## Process Sheet

<b>Customer</b>	CU-DAR001 Dart Helicopters Services	<b>Drawing Name</b>	: 350 SKIDTUBE ASSEMBLY LH
<b>Job Number</b>	: 39972	<b>Part Number</b>	: D350636011
<b>Estimate Number</b>	: 10262	<b>Drawing Number</b>	: D2750 UNDER REVIEW
<b>P.O. Number</b>	:	<b>Project Number</b>	: N/A
<b>This Issue</b>	: 19/06/2008	<b>Drawing Revision</b>	: E
<b>Prsht Rev.</b>	: NC	<b>Material</b>	:
<b>First Issue</b>	: / /	<b>Due Date</b>	: 05/07/2008
<b>Previous Run</b>	: 39971	<b>Qty:</b>	1 Um: Each
<b>Written By</b>	:		
<b>Checked &amp; Approved By</b>	: <u>JUD 08.10.19</u>		
<b>Comment</b>	: Est Rev: I 02-09-25 Rearranged procedure steps KJ : Est Rev: J 06-03-23 As per Rev D JLM : Est Rev: K 06-07-13 As per dsi9343 EC : Est Rev: L 07-07-28 Added SS Wearplates (Rev E) JLM : Verified By: EC : Est Rev: M 08-04-22 update steps 4, 13 DD verified by: EC

# DART SERVICE INSTRUCTION

**FIGURE 1 - WEARPLATE MODIFICATION**

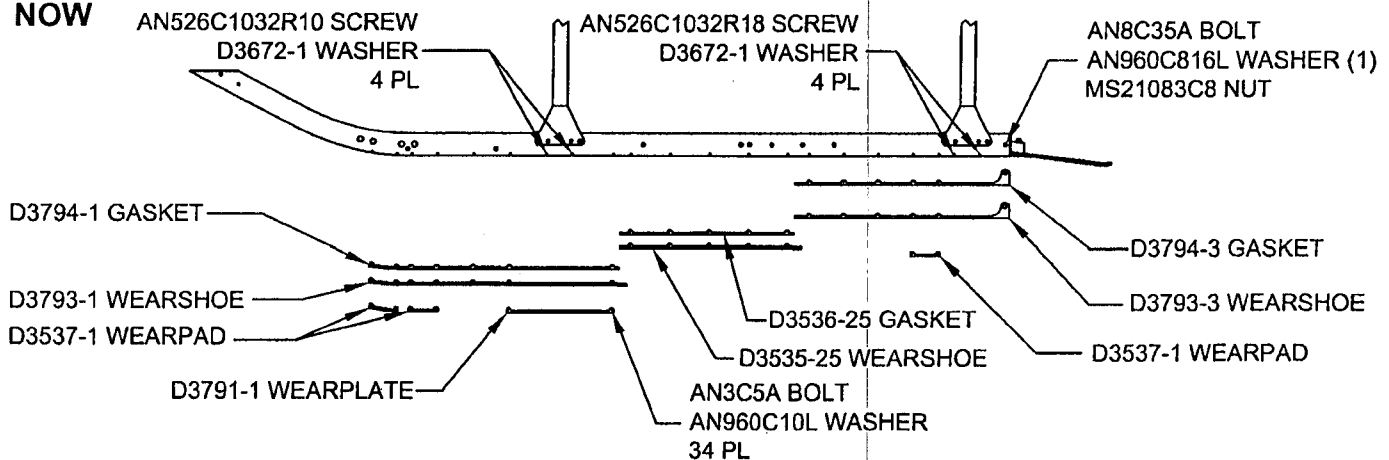
THE WEARPLATES ON D350-636-011/-012/-013/-014 SKIDTUBES AT CHG 004 (AND LATER) HAVE BEEN MODIFIED AS SHOWN IN FIGURE 1 BELOW TO ELIMINATE THE POSSIBILITY OF INTERFERENCE BETWEEN THE WEARPLATES AND CROSSTUBE SADDLES AT INSTALLATION. THERE IS NEGLIGIBLE WEIGHT CHANGE ASSOCIATED WITH THIS MODIFICATION.

(AN526C1032RXX SCREW LOCATIONS NO LONGER USED TO MOUNT WEARSHOES)

TO INSTALL THE DSI 9413-011 KIT, REMOVE THE EXISTING WEARSHOES/GASKETS UNDER THE FWD/AFT SADDLES AND INSTALL NEW WEARSHOES/GASKETS AS SHOWN IN FIGURE 1. PLUG UNUSED HOLES WITH AN526C1032RXX SCREWS AND D3672-1 WASHERS. INSTALL SCREWS WITH SIKAFLEX -241/-291 OR PROSEAL 890 OR MIL-S-8802 CLASS 'B2' SEALANT AS SHOWN IN FIGURE 1. NOTE: SOME OF THE PREVIOUSLY INSTALLED HARDWARE IS NO LONGER REQUIRED.
